# SERVICE BULLETIN

## Outrigger Component Replacement

**SB97.2****Machines/Models: TL49****Serial Nos.: 1001-1056****THIS BULLETIN IS MANDATORY.****DATE:** February 1, 1997**PURPOSE:** To replace the present pin lock plates, banjo bolts, and dowty washers with current specifications.**OPERATION REQUIRED:** Replacement of pin lock plates, banjo bolts, and dowty washers.**PARTS REQUIRED: (Figure 1)**

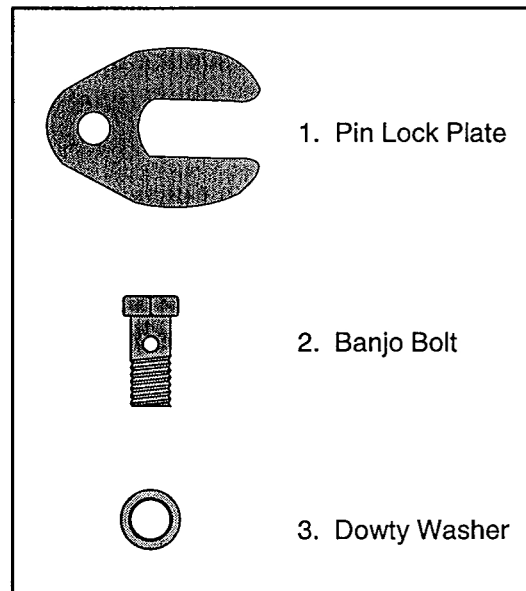
1. 12 ea. 058056-000 Pin Lock Plates
2. 08 ea. 058188-000 Banjo Bolts
3. 16 ea. 057124-000 Dowty Washers

Figure 2

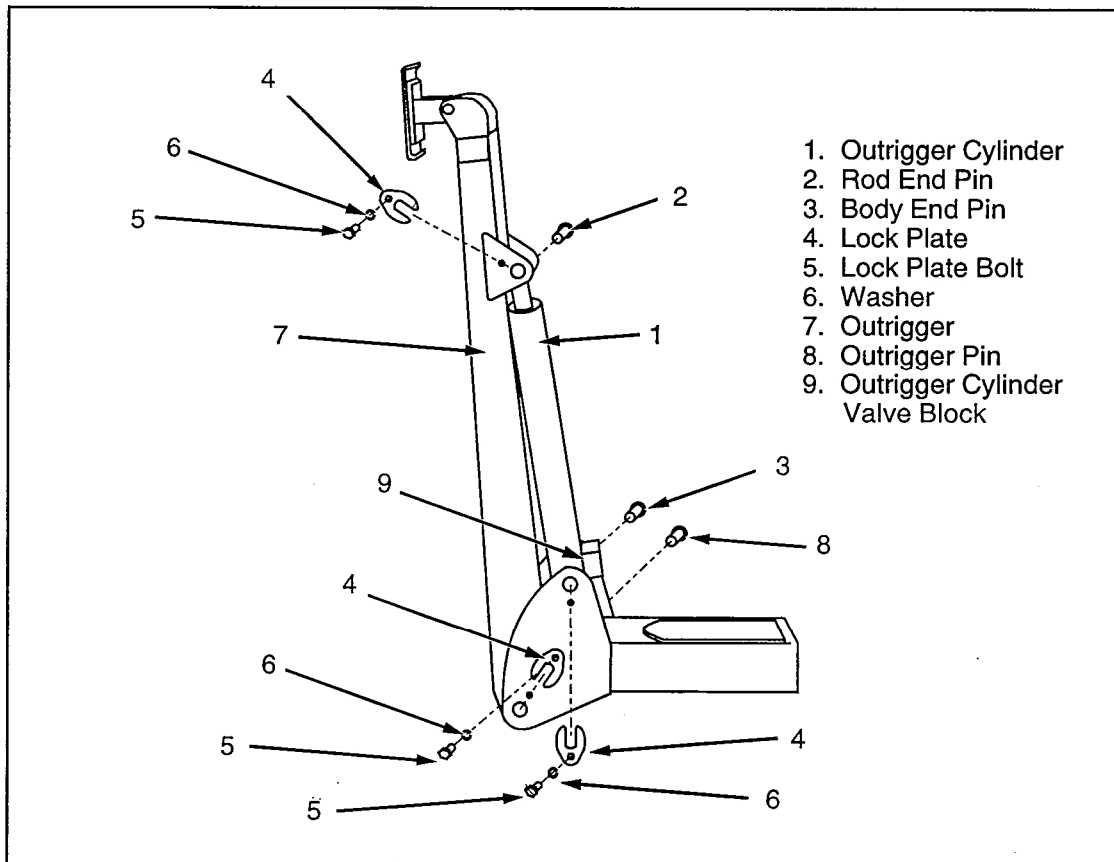
1. Ensure that the TL-49 is on a firm level surface and not raised, i.e. it is supported by its wheels and also that the outriggers are extended until they touch the ground but that they bear no load. The procedure written below are the steps to replace one set of lock plates and should be repeated for each of the other three outriggers.
2. Remove the securing bolts #5 and washers #6 from the three pin lock plates. (fig. 2)
3. Remove the three pin lock plates #4 (fig. 2).
4. Install supplied pin lock plates #4 (fig. 2).
5. Apply medium strength thread lock to lock plate securing bolt, install bolt #5 and washer #6 to each pin lock plate (fig. 2). Torque to 25 ft. lbs.

Figure 3

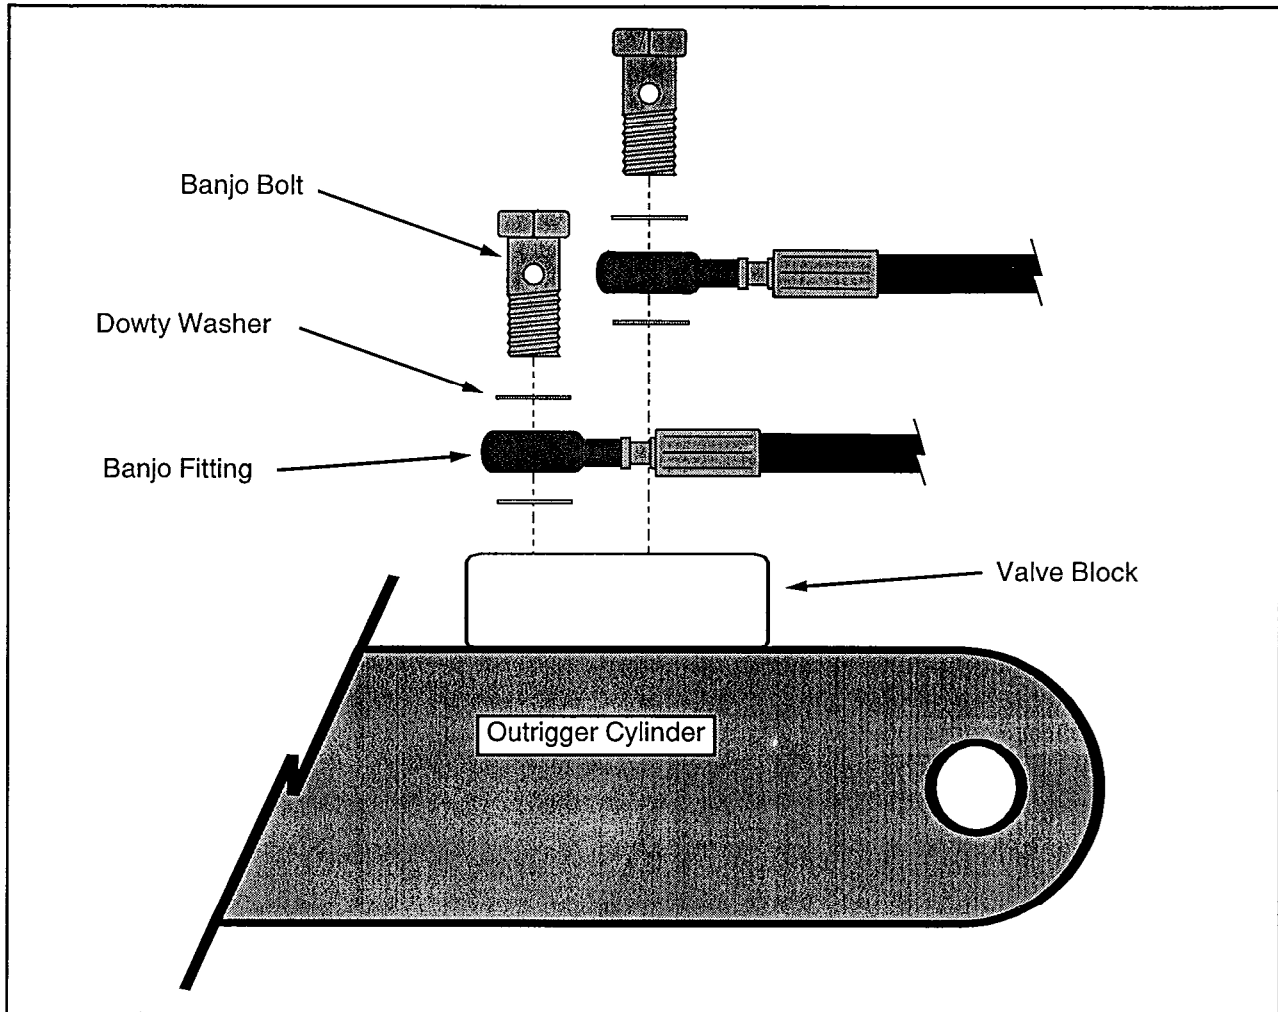
1. Remove existing banjo bolts and dowty washers, retain for return to factory.
2. Install replacement banjo bolts, dowty washers, and existing banjo fittings onto outrigger cylinder valve block per figure 3.
3. Torque banjo bolts to 25 ft. lbs.
4. Cycle each cylinder to bleed any air from system and test operation.
